Subject: Unresolved Item 94-22-01, Makeup Tank Operation

Facility Name: Crystal River Nuclear Plant Unit 3

CURVE 8A, 8B & 8C OPERATIONAL CRITERIA

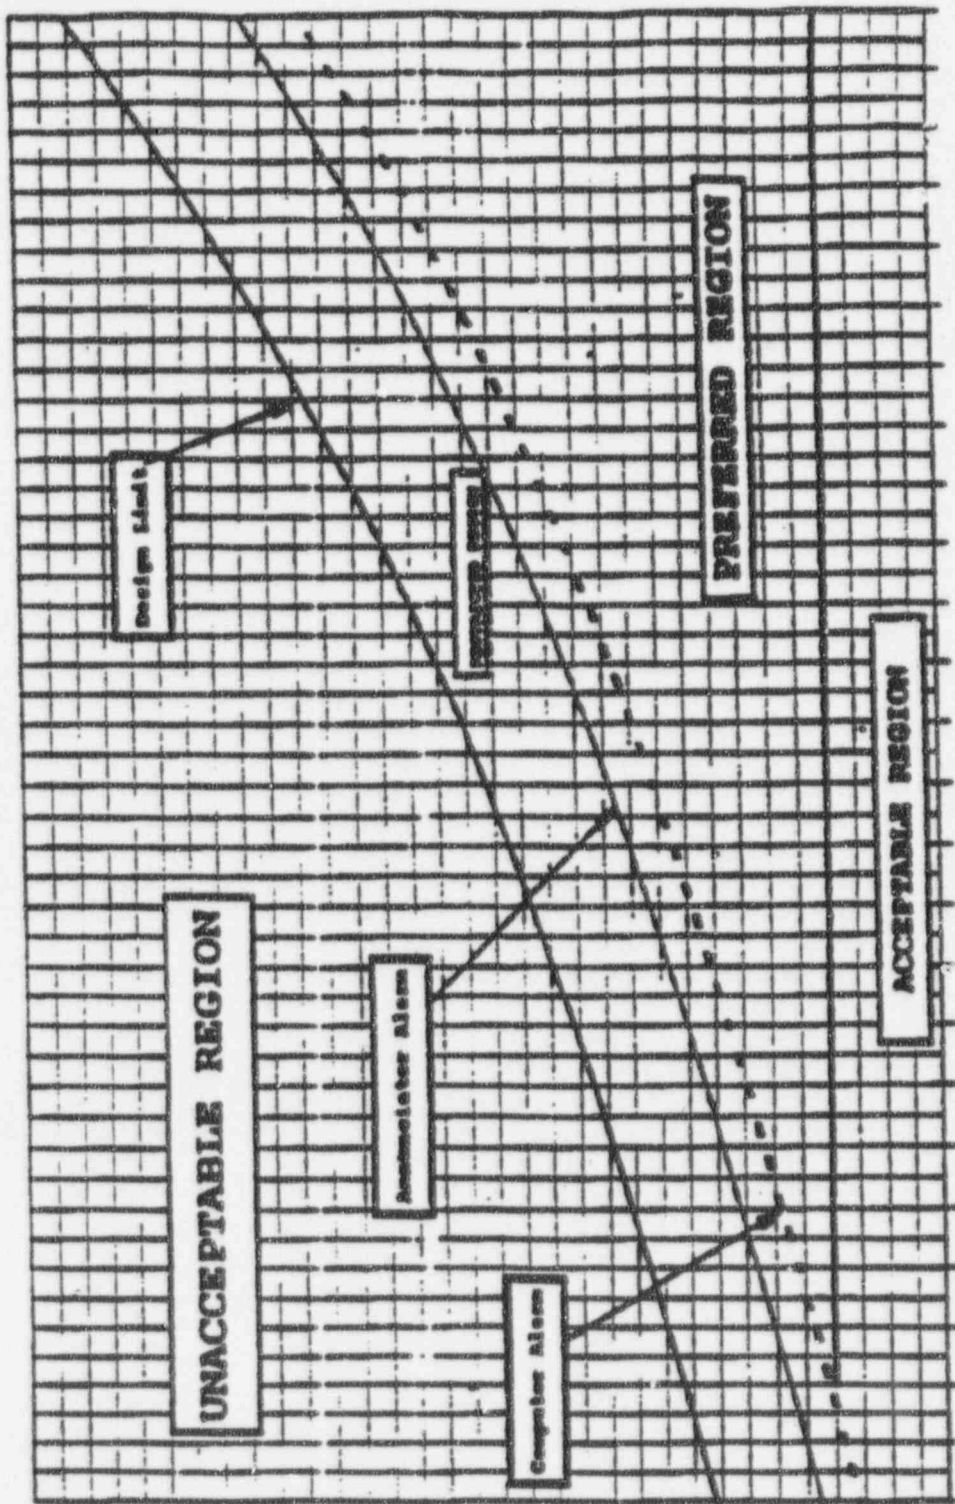
The DESIGN LIMIT curve is based on Engineering Calculation M94-0053, Rev. 2.

- o The DESIGN LIMIT curve is based on instrument error for pressure and level as read from MU-14-LTRI.
- o The UNACCEPTABLE REGION is on or above the DESIGN LIMIT curve. Operation in the UNACCEPTABLE REGION shall require an evaluation in accordance with CP-111 'Initiation and Processing of Precursor Cards and Problem Reports'.

- o The ANNUNCIATOR ALARM is a variable alarm based on a Pressure/Volume relationship for the makeup tank and initiates at 3 psi below the design limit curve at a level of 55 inches.

Exceeding the ANNUNCIATOR ALARM will require operator action in accordance with the appropriate Annunciator Response Procedure. This area is considered a RESTRICTED REGION.
